MANCHESTER TOWNSHIP PLANNING COMMISSION AGENDA

Wednesday – **September 24, 2025** – 6:00 p.m.

Re: Abram B. & Amy Hunsberger Subdivision
Final Subdivision Plan
Manchester Township Plan #2025-09
Engineer's Project No. 0841.3.08.77

Re: Penn Avenue Residential
Preliminary Land Development Plan
Manchester Township Plan #2025-05
Engineer's Project No. 0841.3.16.69

TYPICAL GREENBRIAR ROAD CROSS SECTION

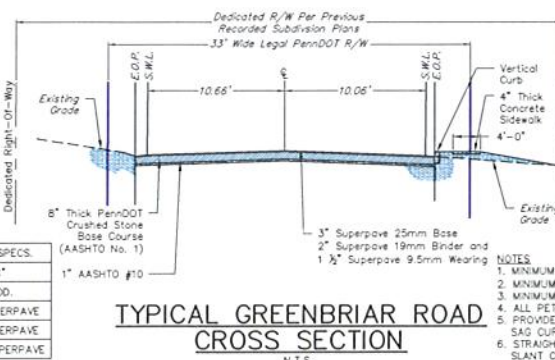
2. Add a typical street cross-section depicting the Greenbriar Road dimensions and future curb and sidewalk improvements.
3. Greenbriar Road shall be determined whether it is considered an arterial street within the Township's Comprehensive plan. Note 8 within the site data table shall be revised accordingly.

PROJECT NO.	22-0108-008
DATE:	04/07/25
SCALE:	1" = 50'
SHEET	C-803

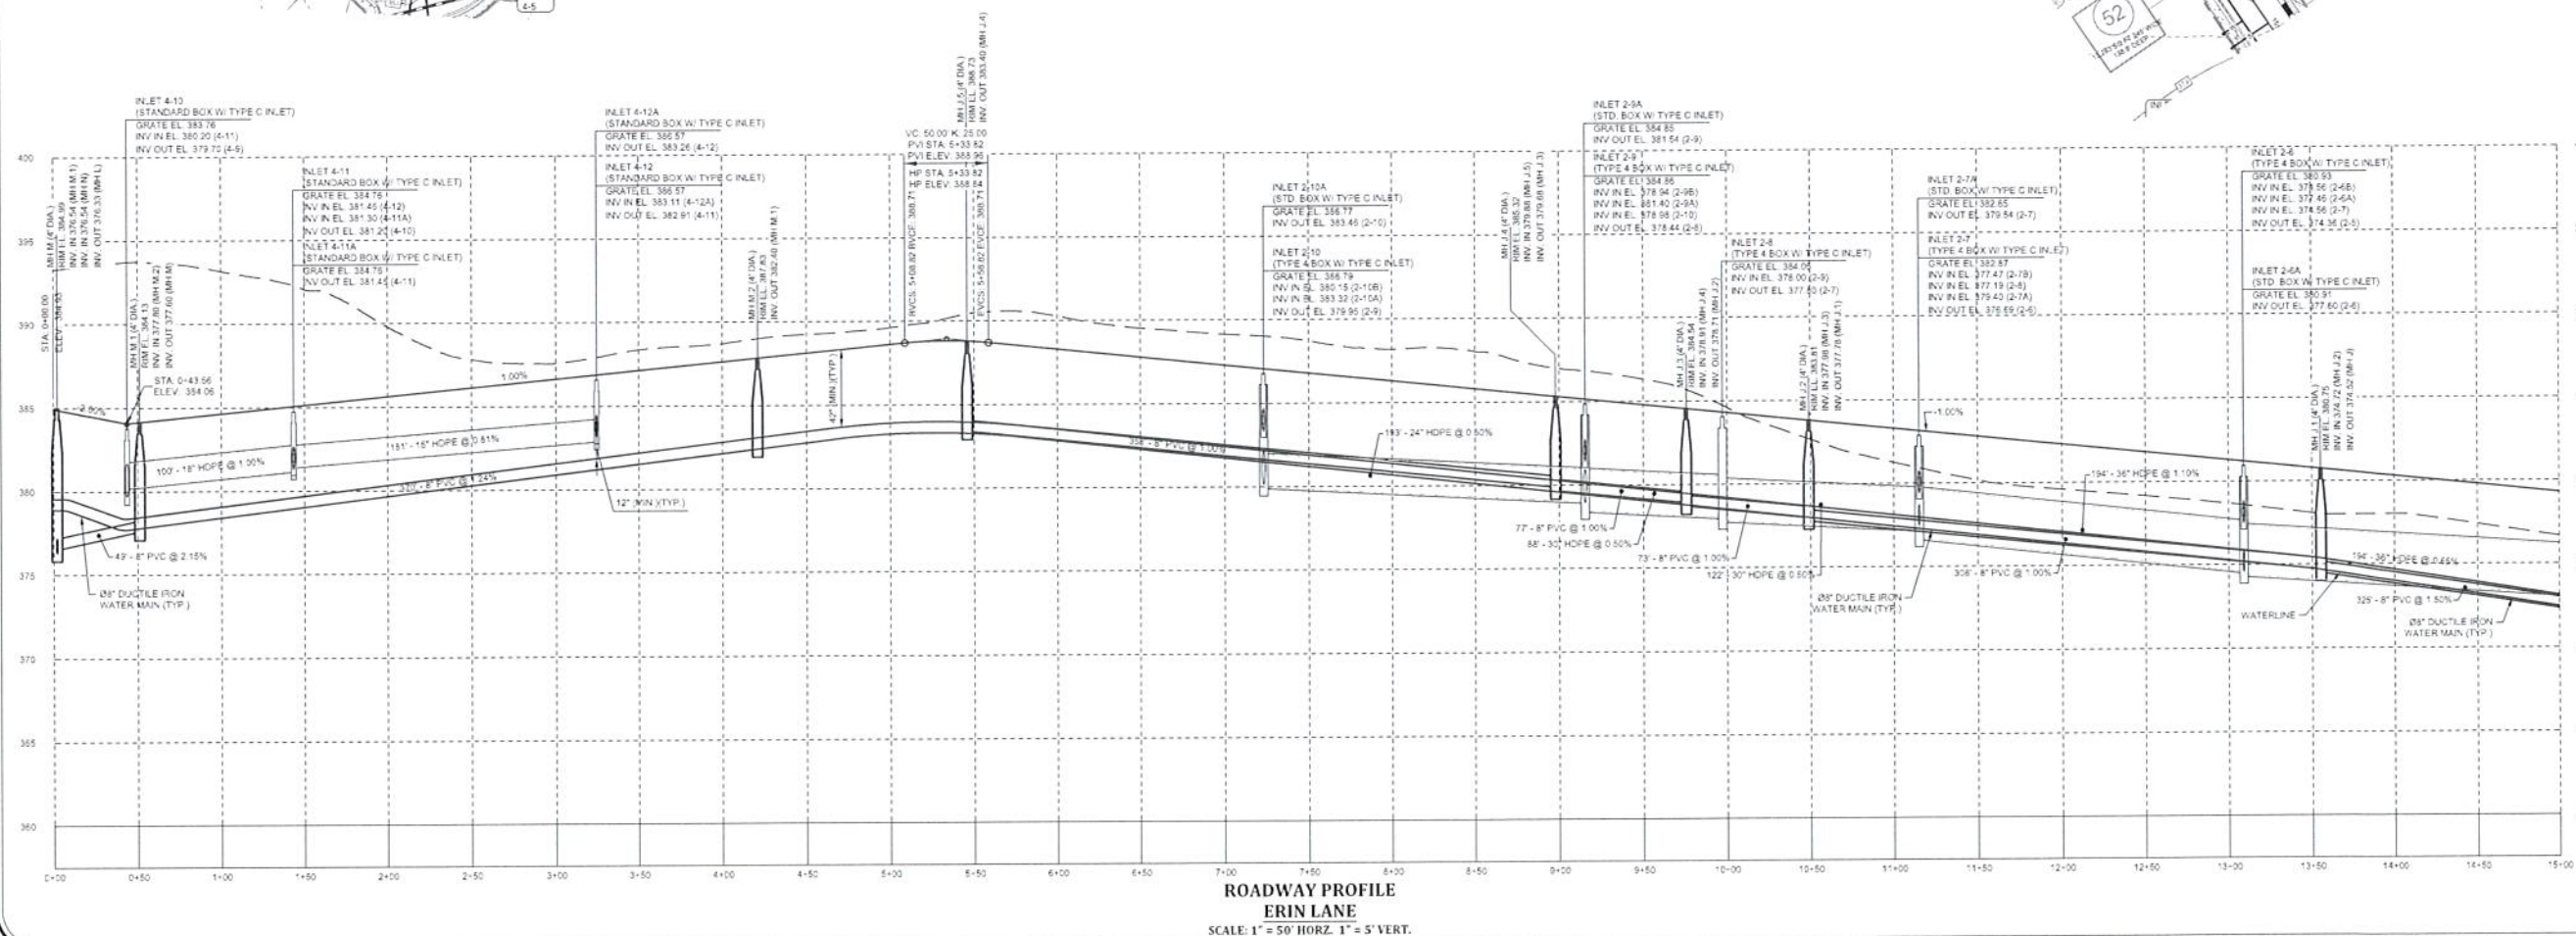
30. The sanitary sewer main between MH D and MH E is missing from the profile on sheet C-803.
31. Inlets 2-11A and 2-12A shall be relocated so as not be in conflict with the crosswalk or vice versa, see sheet C-802.

STANDARD FRAME AND COVER

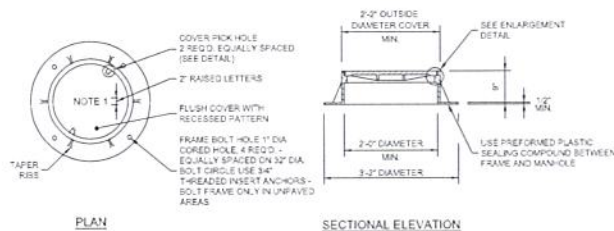
2. Revise the "slant curb to Type C inlet transition" detail on sheet C-1001 to show a minimum 5' transition.
3. Revise the "standard frame and cover lettering" detail on sheet C-1003 for consistency with the Manchester Township Construction and Material Specifications – "MAN TWP SANITARY SEWER".

MANHOLE STEPS

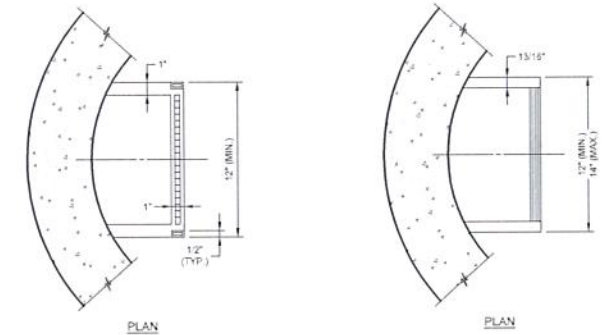
4. Revise the "manhole steps" detail on sheet C-1003 to identify a min. length of 7" for consistency with the Manchester Township Construction and Materials Specifications.

SANITARY SEWER MANHOLE

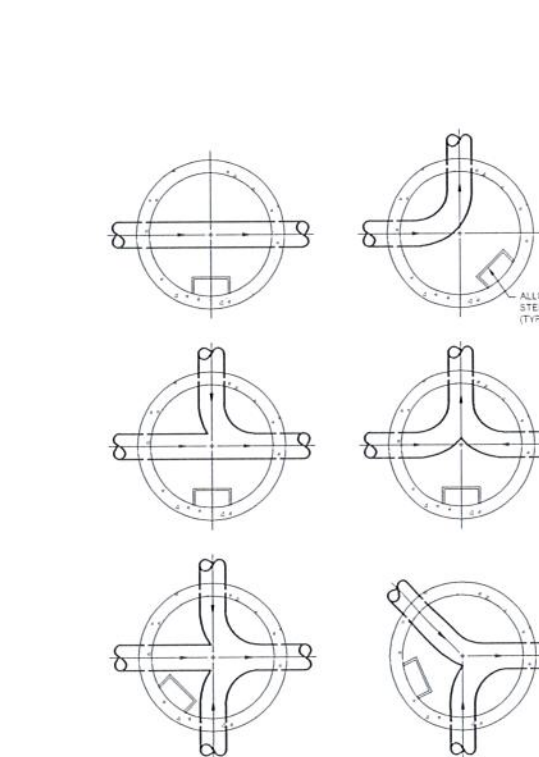
5. The sanitary sewer manhole detail shall allow a maximum 22" to the first step on sheet C-1003.
6. Additional survey/topography/significant features must be shown in the vicinity of SWM BMP #1 discharge to properly evaluate potential downstream impacts.
